| U. S. ARMY ENGINEER DISTRICT, NEW ORLEANS CORPS OF ENGINEERS NEW ORLEANS, LA. | | | |

THIS PLAN ACCOMPANIES
MODIFICATION TO
CONTRACT NO. DACW29-
67-C-0196 - P002

PROFILE AND BORINGS

| 3 | 2/20/67 | General revisions, Mod. # P002 | D.J.H. |
|-----------------|----------------------------|------------------------------------|--------|
| SCALE: AS SHOWN | SPEC. NO. DACW29-67-B-0136 | DWG. NO. 2 | OF 5 |

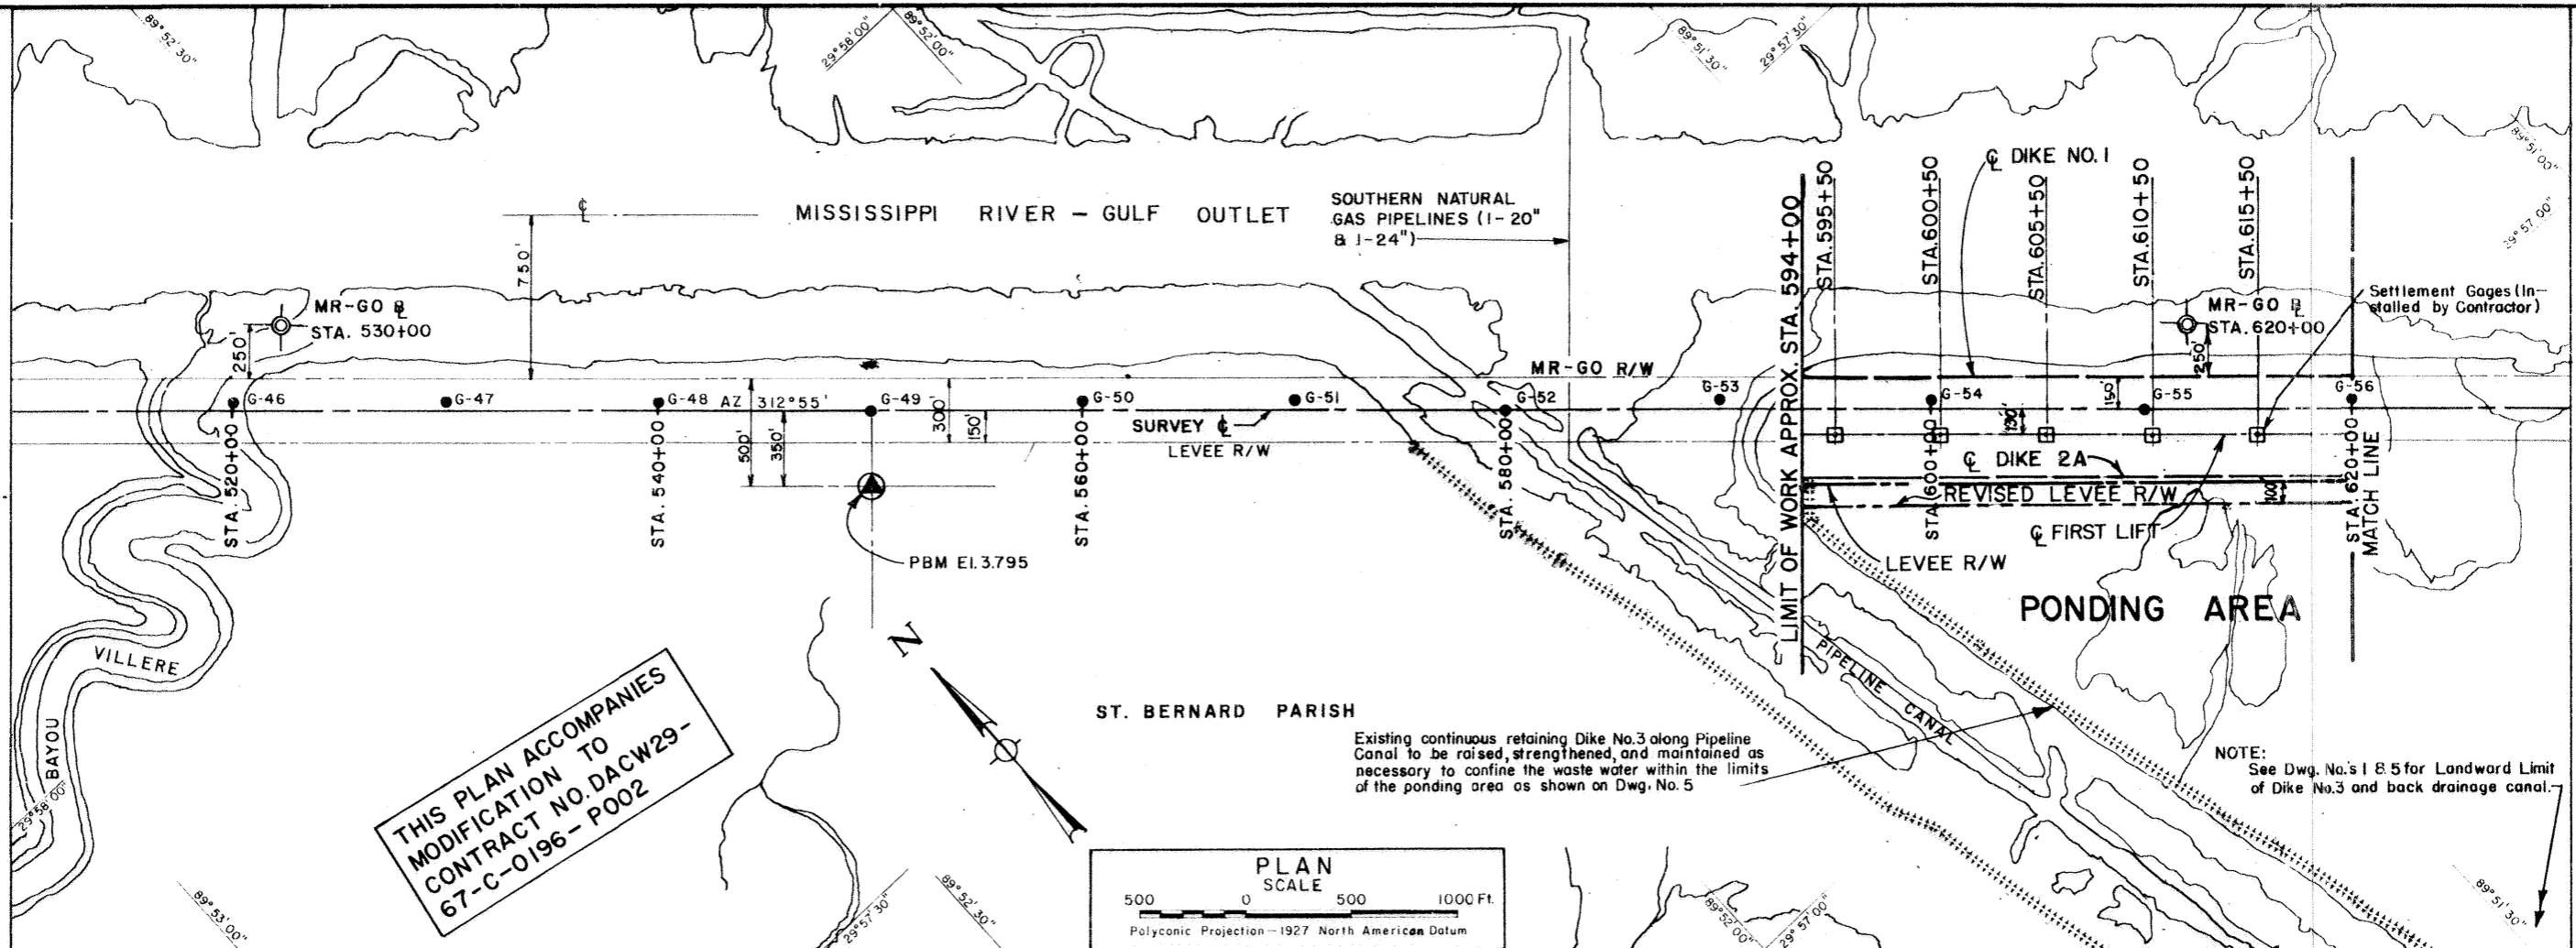
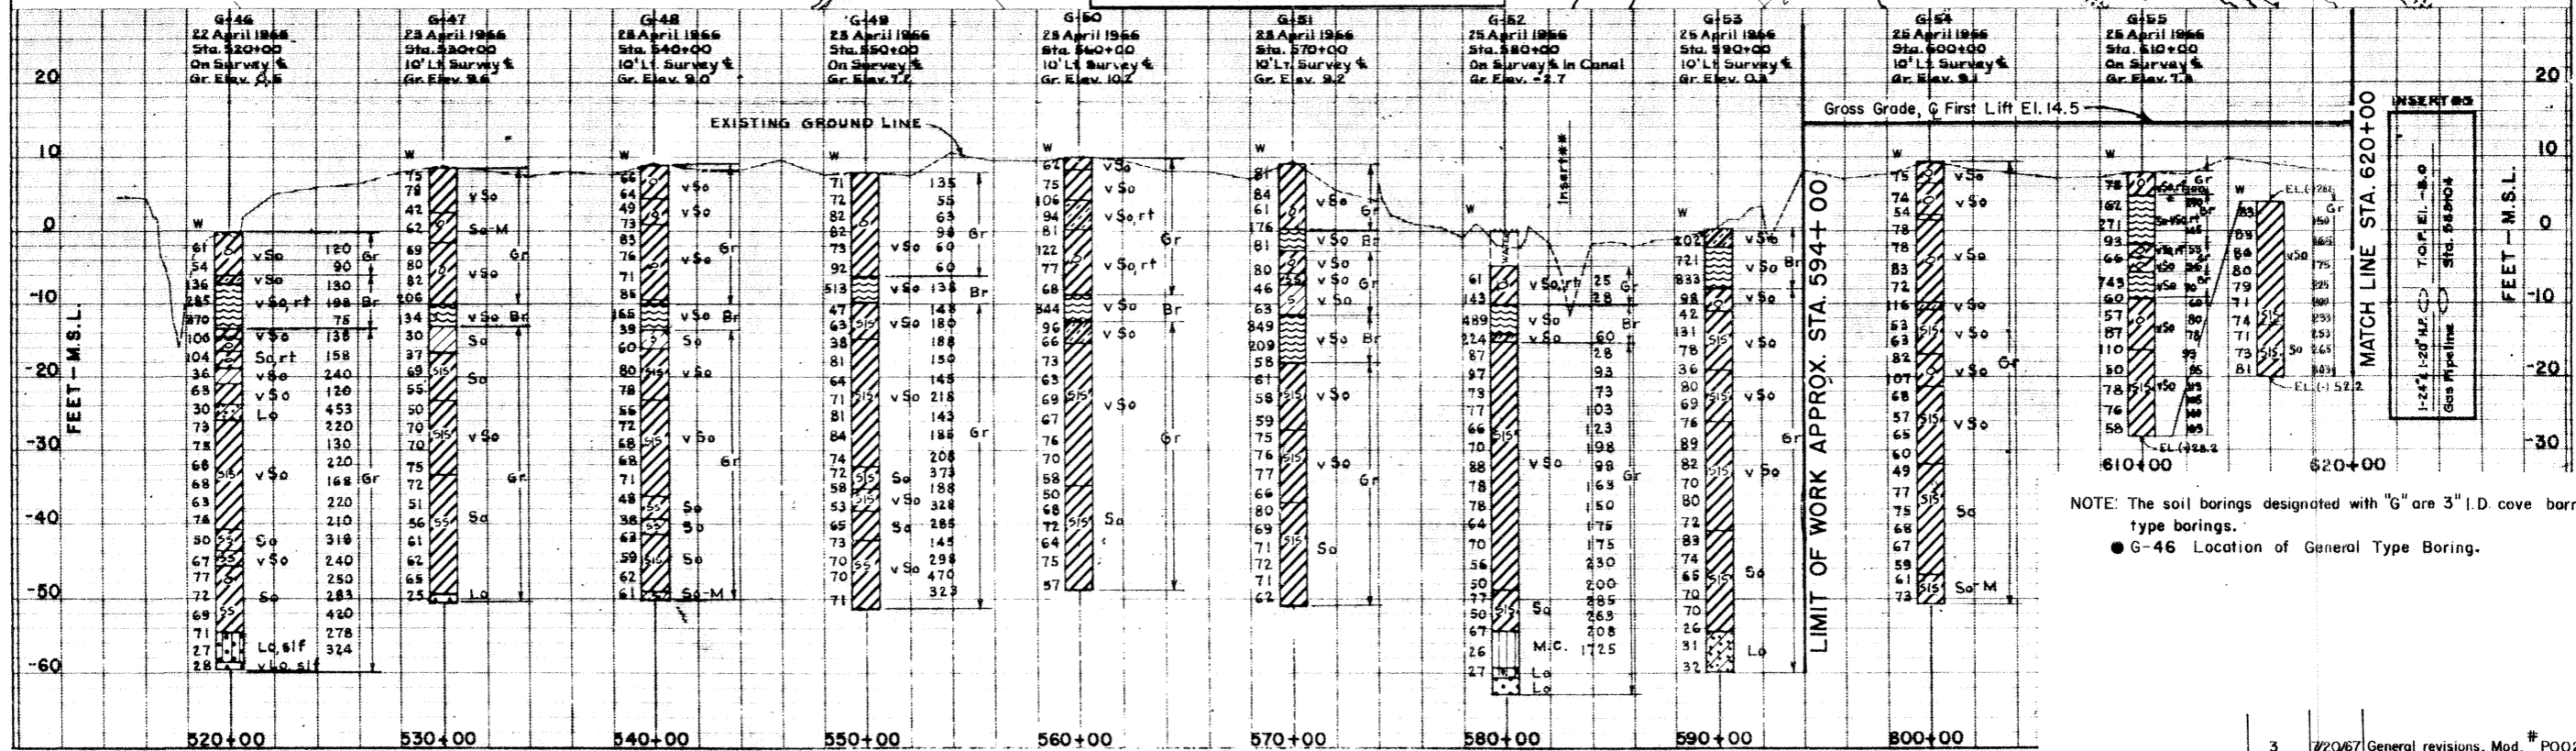
Existing continuous retaining Dike No.3 along Pipeline Canal to be raised, strengthened, and maintained as necessary to confine the waste water within the limits of the ponding area as shown on Dwg. No. 5

| 3 | 2/20/67 | General revisions, Mod. # P002 | D.J.H. |

| 3 | 2/20/67 | General revisions, Mod. # P002 | D.J.H. |
|---|---------|-------------------------------------|--------|
| SCALE AS SHOWN SPEC. NO. DACW29-67-B-0136 Dwg. No. 3 of 5 | | | |

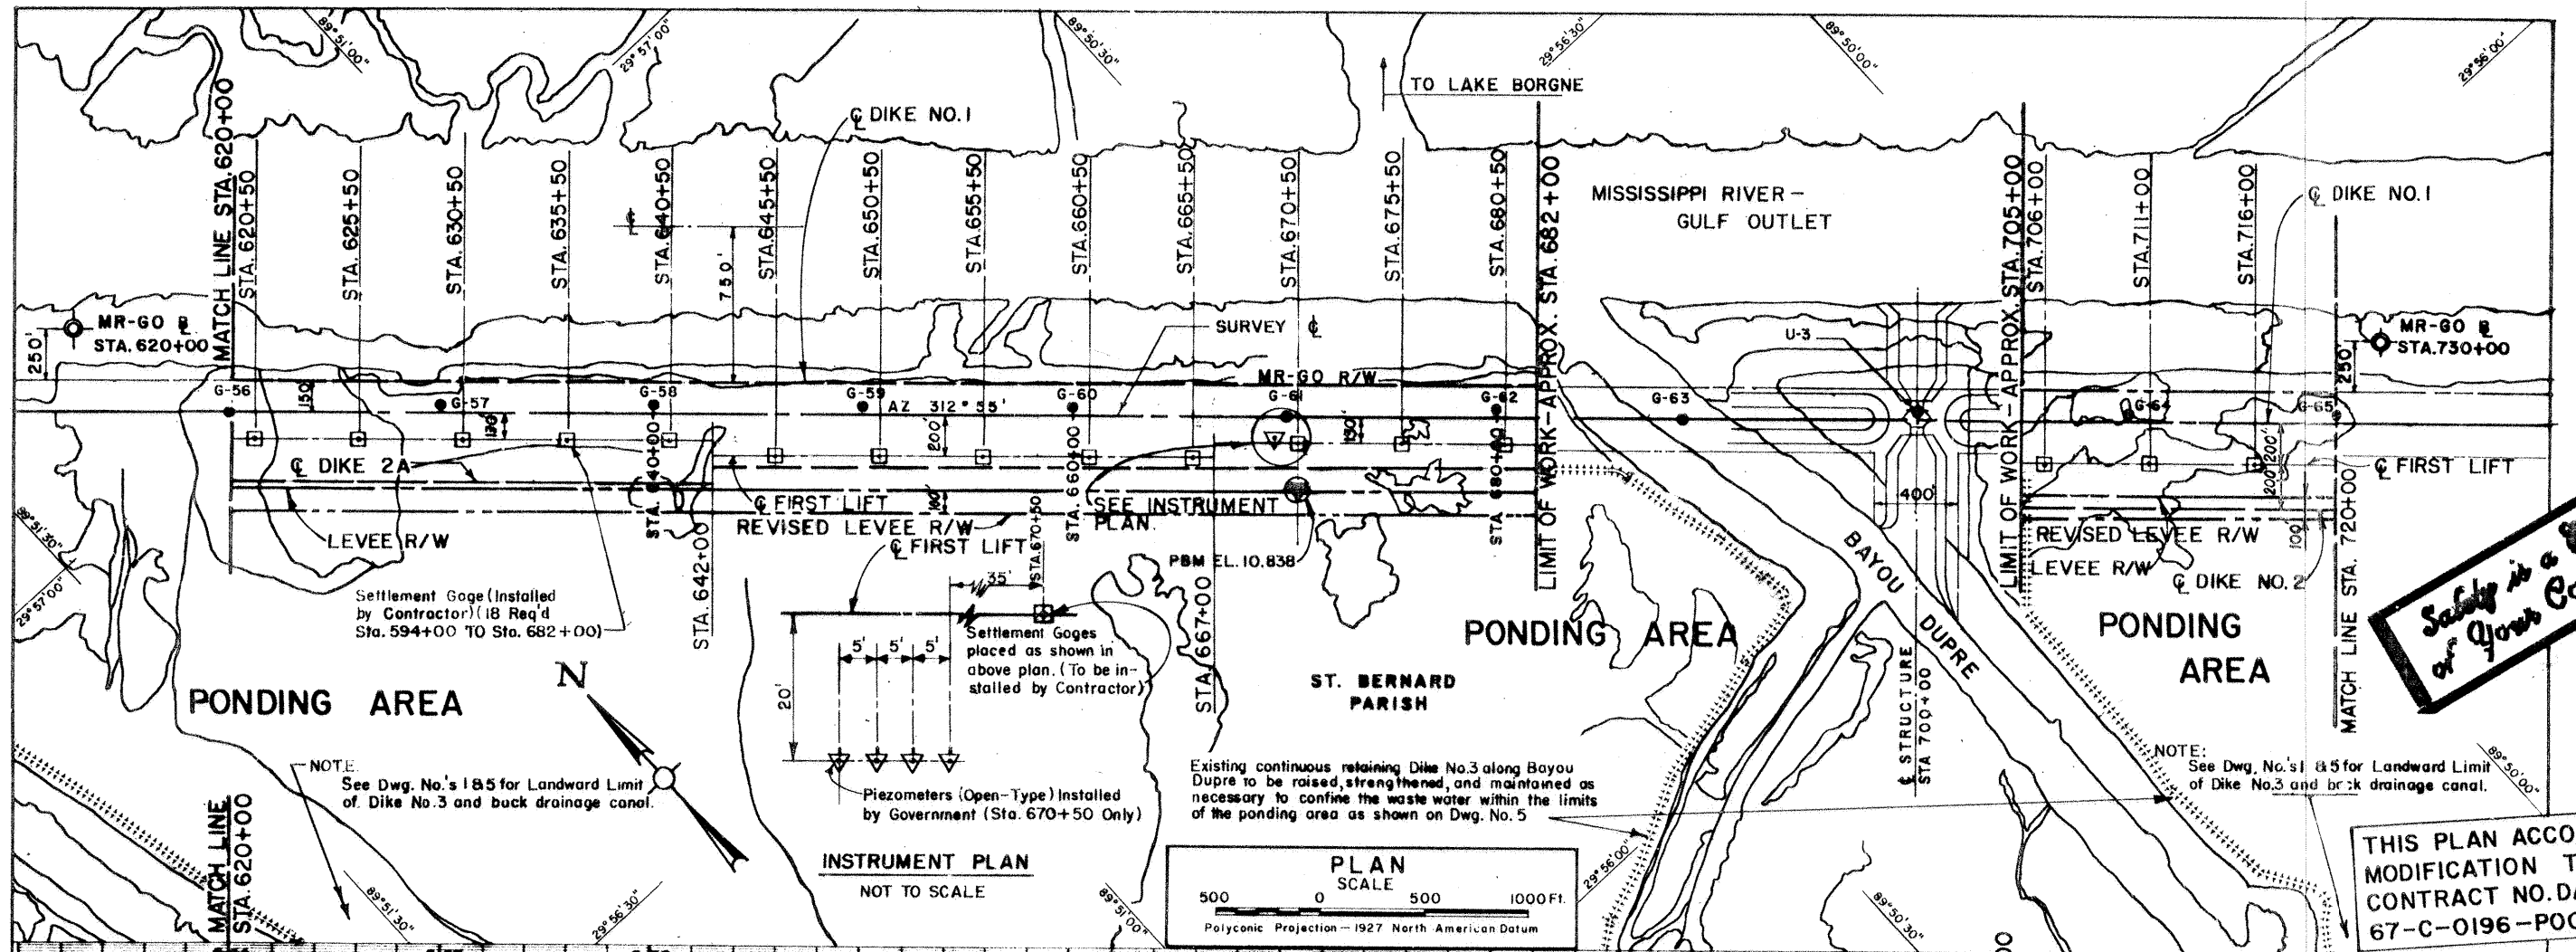
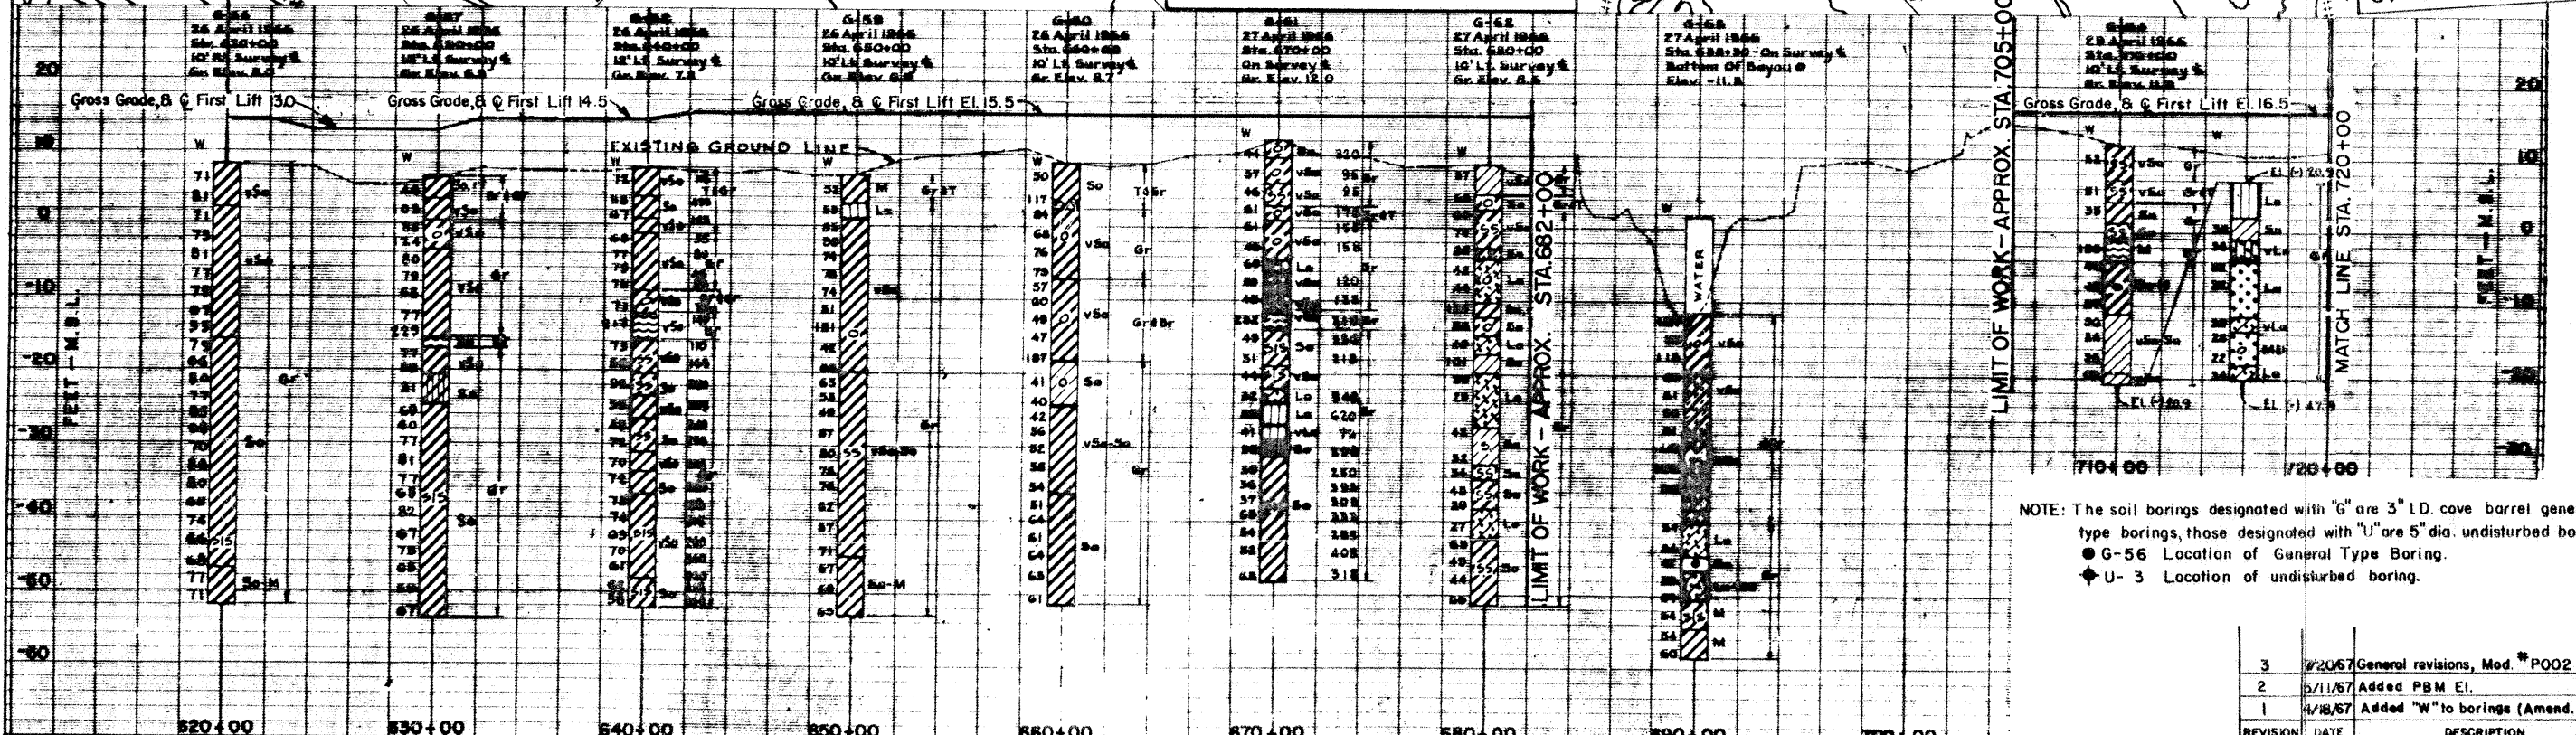
| 3 | 2/20/67 | General revisions, Mod. # P002 | D.J.H. |
